CUSTOMER TECHNICAL MEMO # 145

Subject: New AS106E End Caps

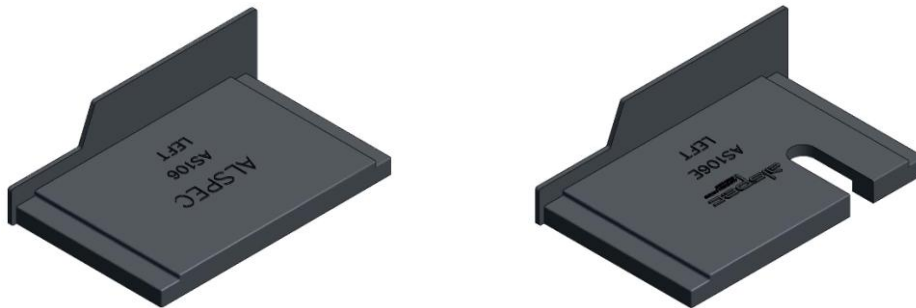
We are please to advise that we have upgraded our AS106E End Caps to include a 10mm x 30mm slot to allow for jamb drainage of any water back into the sub sill.

Please see below images of the old (left) and the new End Cap (right) showing the differences.
